Interactive comment on “Assessing hydrological effects of human interventions on coastal systems: numerical applications to the Venice Lagoon”

by C. Ferrarin, M. Ghezzi, G. Umgiesser, D. Tagliapietra, E. Camatti, L. Zaggia, and A. Sarretta.

Hydrol. Earth Syst. Sci. Discuss., 9, 13839-13878, 2012

Response to Anonymous Referee #1

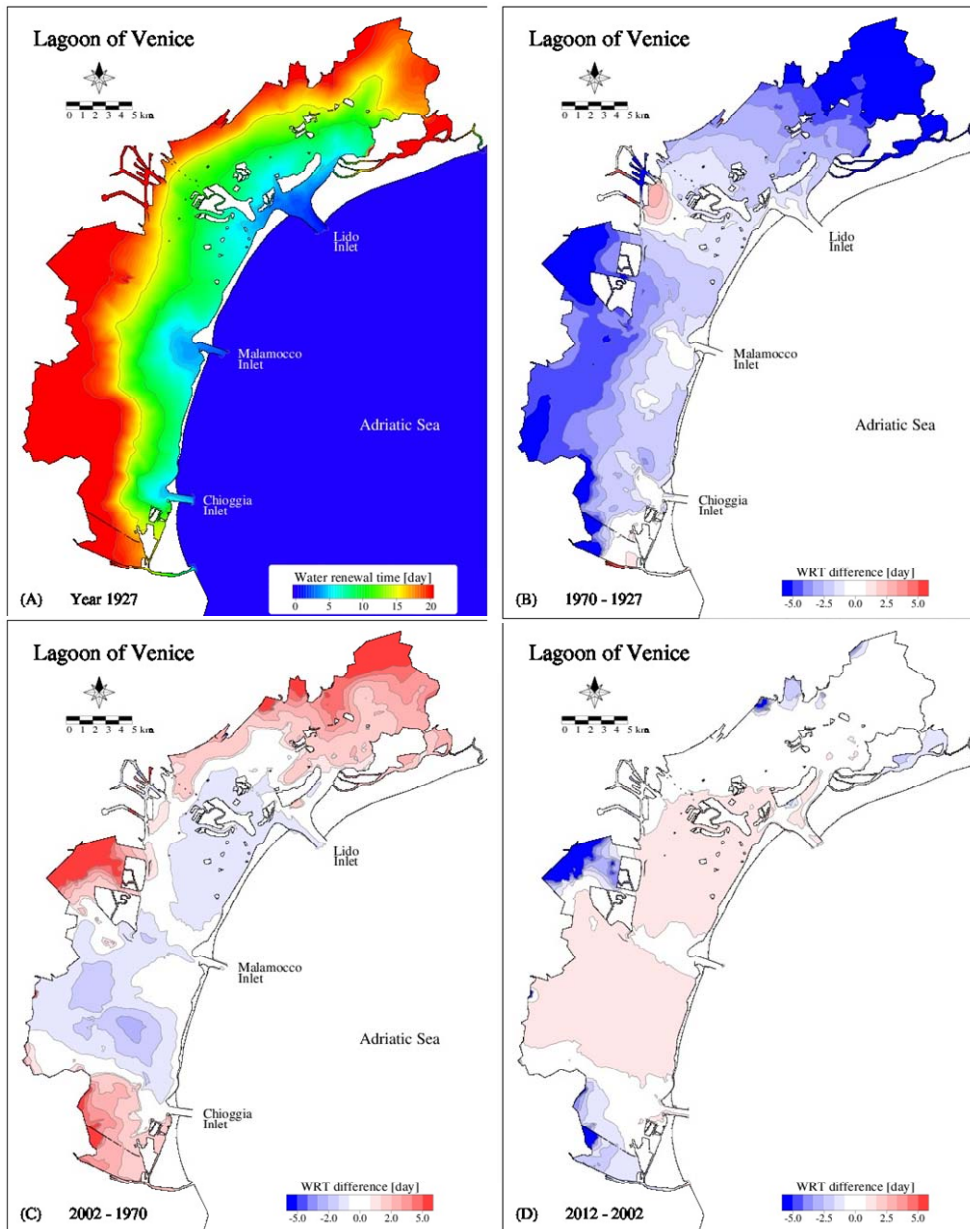
Q(7). *Figures 4 and 6 are very hard to read at the presented scale. Each of these figures includes 4 maps of the spatial distribution of Water Renewal Time. It takes the reader considerable effort to compare between them and verify the explanation in the relevant text. a. All these figures should be converted to the spatial distribution of the difference (or %) in change between a reference scenario (for example 2002) and the other studied scenarios (i.e., (WRT-WRT2002), or*

(100(WRT-WRT2002)/ WRT2002)); respectively). Such spatial distributions will directly point the reader to areas of change and the magnitude and trend of change (+ or -) relevant to each scenario. b. Figure 4 (A) shows year 1930. It should be consistent with the text indicating the year 1927.*

R(7): We modified Figures 4 and 6 according to the reviewer comment showing the spatial distribution of the difference between scenarios (in days). Figure 4 presents now the Water Renewal Time distribution for year 1927 (Figure 4A), the difference in WRT between 1970 and 1927 (Figure 4B), the difference in WRT between 2002 and 1970 (Figure 4C) and the difference in WRT between 2012 and 2002 (Figure 4D). Figures 4B-D now well correlate with Figure 5 enhancing the clarity of the discussion. Figure 6 presents now the WRT distribution for the scenario with no SLR and closure of the inlets (Figure 6A), the difference in WRT between scenarios SLR_10 and SLR_00 (Figure 6B), the difference in WRT between scenarios SLR_30 and SLR_00 (Figure 6C) and the difference in WRT between scenarios SLR_50 and SLR_00 (Figure 6D).

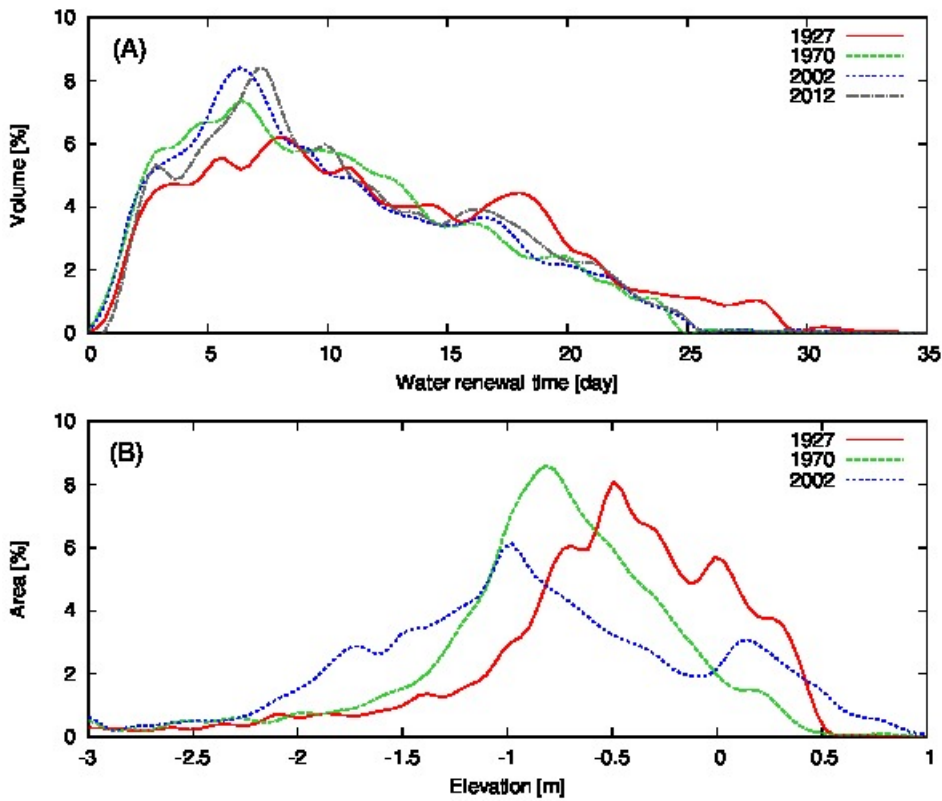
Q(8). *Figure 5 and the relevant text (page 13852): a. The two figures should be separated into two independent figures because their horizontal axes are different. b. Otherwise, they should be identified as (A) Water renewal time, and (B) Bathymetry. The caption should mention these figures. c. For consistency, the word “bathymetry” should be changed to “elevation” in the caption. d. The legend for Figure (B) should not have the data for 2002. The caption for figure (B) should alert the reader that the 2002 data does not exist. e. The authors should identify the reference datum (zero elevation) for the measurements in both figures. f. To validate any quantitative comparison between the two graphs, the vertical axes should have the same scale and units [e.g., Area (km²), or Area (%)].*

R(8): Figure 5 was partially modified according to reviewer suggestions: (a, b) The two figures have been identified as (A) Water renewal time and (B) Elevation, and the caption mentions these figures; (c) the word bathymetry in the caption has been changed to elevation; (d) 2012 label has been deleted from Figure 5B and the caption now mentions that there is no bathymetry dataset for 2012; (e) The two figures are both referred to the free floodable surface of the Venice lagoon. The vertical axes of the figure 5B is now expressed as Area (%) and the datum of elevation has been specified in answer R(2) and R(6); (f) The water residence time is referred the whole area of the Venice lagoon, but it is calculated on the volume of the water column as specified in the methodology section. The relation between elevation and water renewal time is mediated from the effect of the changes in the spatial distribution of the morphologies on the water circulation (as showed in the figure reporting the difference between water renewal time in different years.). We are not calculating a balance between areas, but illustrating the cause-effect relationship between WRT and elevation. This figure is now discussed together with Figure 4.

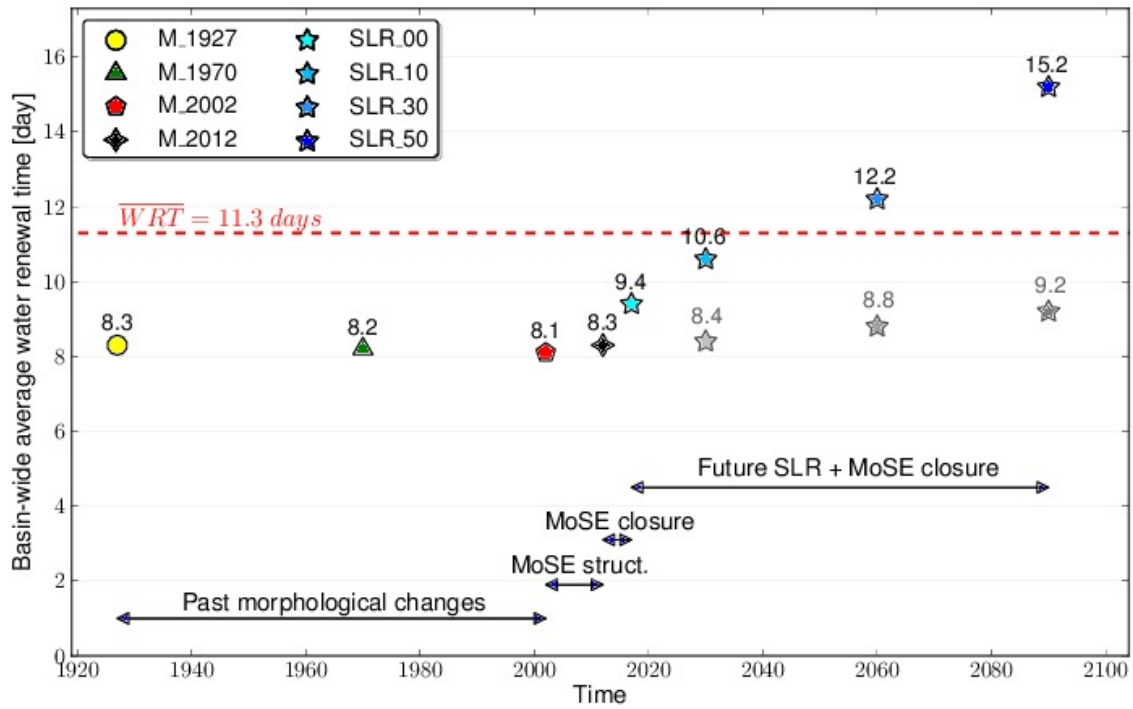
Q(4). *Baseline simulations should be included for the effect of Sealevel Rise on Water Renewal Time without any closures of the MoSE. These simulations will show the actual degree of choking these barriers are causing to the Lagoon.*

Q(9). *Figure 7: The horizontal axis should be changed to reflect the time from 1927 into the future. The expected times for SLR of 10, 30, and 50 cm can be estimated from relevant literature or models. A legend similar to that in Figure 8 should be added to figure 7.*

R(4): We carried out the mentioned simulations. The results of these simulations are presented in Figure 7 and discussed in the manuscript in the following paragraph: “In order to investigate the degree of choking the MoSE barriers are causing to the Lagoon we carried out three additional simulations which consider SLR without any closure of the inlets during high tide events. Basin-wide average water renewal times of these simulations are 8.4, 8.8 and 9.2 days for a SLR of 10, 20 and 30 cm respectively. Increase in the WRT is only due in this case to the increase in the lagoon volume which is not fully compensated by the increase water fluxes through the inlets. As shown in Figure 7, where results of these simulations are presented as gray stars, closing the MoSE barriers will have a stronger effect on water renewal in comparison with only SLR”.

R(9): We modified Figure 7 according the suggestions of the reviewer changing the horizontal axis to time from 1920 to 2100 and adding the legend. Moreover we included the following sentence in the manuscript (Section 2.3.: Simulation set-up): “The expected times for SLR of 10, 30 and 50 cm can be estimated to be 2030, 2060 and 2090, considering that recent observations find sea level tracking at the upper range of IPCC projections (Allison et al., 2009, Umgiesser et al., 2012)”.

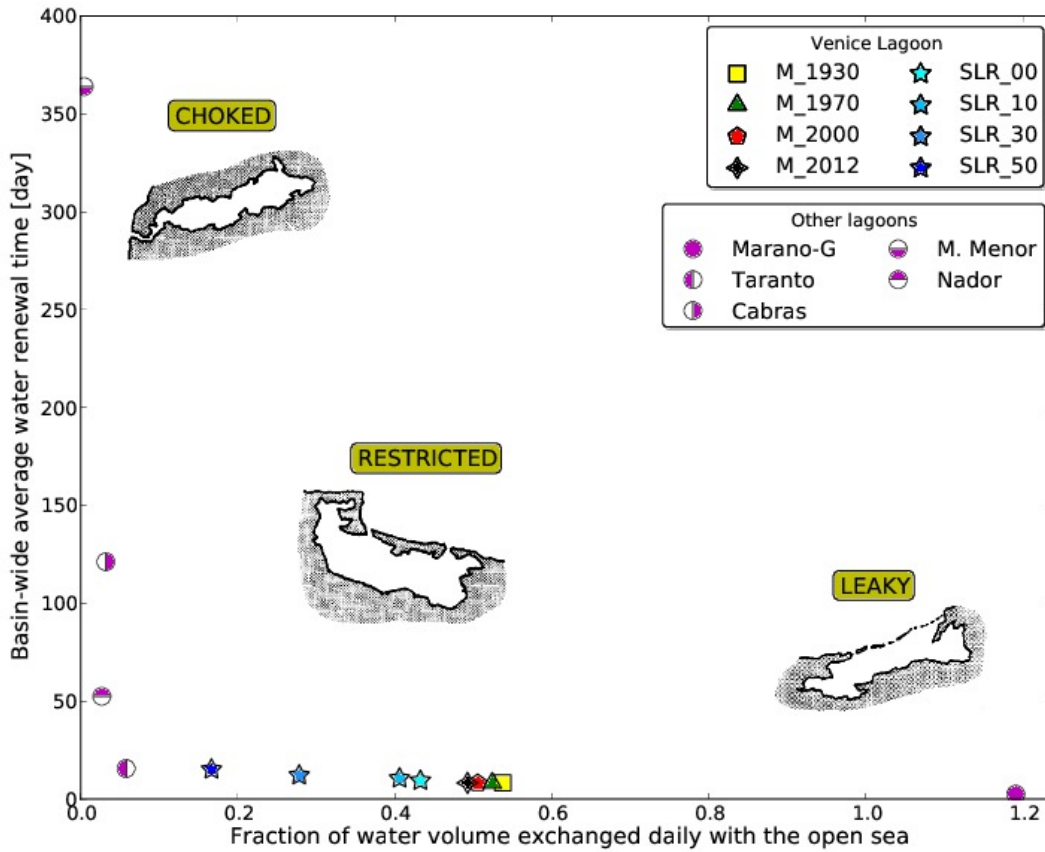
Q(10). Figure 8: a. The sketches showing leaky, restricted, and choked waterbody are very qualitative and they are not relevant to Venice Lagoon. The main cause of the restriction to the lagoon is the frequent operation of the MoSE. These sketches should be removed. b. Introducing the “flushing time,” which is a different time scale, is confusing. Should the vertical axis represent average water renewal time or flushing time? In addition, the curve showing flushing time does not add anything new to the analysis and it should be removed from the figure together with the relevant text (page 13855, paragraph 3). c. With the above adjustments to the figure, the eight data points should plot on a relevant vertical axis with a maximum similar to that in Figure (7) to delineate the trend with FVE, which should be similar to that in Figure 7 but reversed.

R(10): We agree with the reviewer that these sketches (from Kjerfve and Magill(1989)) are qualitative, but they are commonly used to describe different types of lagoons. With this figure, which includes the leaky, restricted and choked water body sketches, we want to broaden this study on the more general context of the classification and characterisation of lagoons. For this purpose, Figure 8 now reports also the numerical results, obtained by applying the same model SHYFEM, of other five Mediterranean lagoons: the Marano-Grado Lagoon in the Northern Adriatic Sea, the Taranto basin in the Ionian Sea, the Cabras Lagoon in Sardinia, the Mar Menor in Spain and the Nador Lagoon in Morocco. These environments range from a leaky type to a choked type of basins and give a representative picture of the coastal lagoons situated around the Mediterranean Sea. Details of model application to these lagoons can be found in the cited references.

We agree with the reviewer that the flushing time in this figure is confusing and therefore we removed it and not discussed in the manuscript.
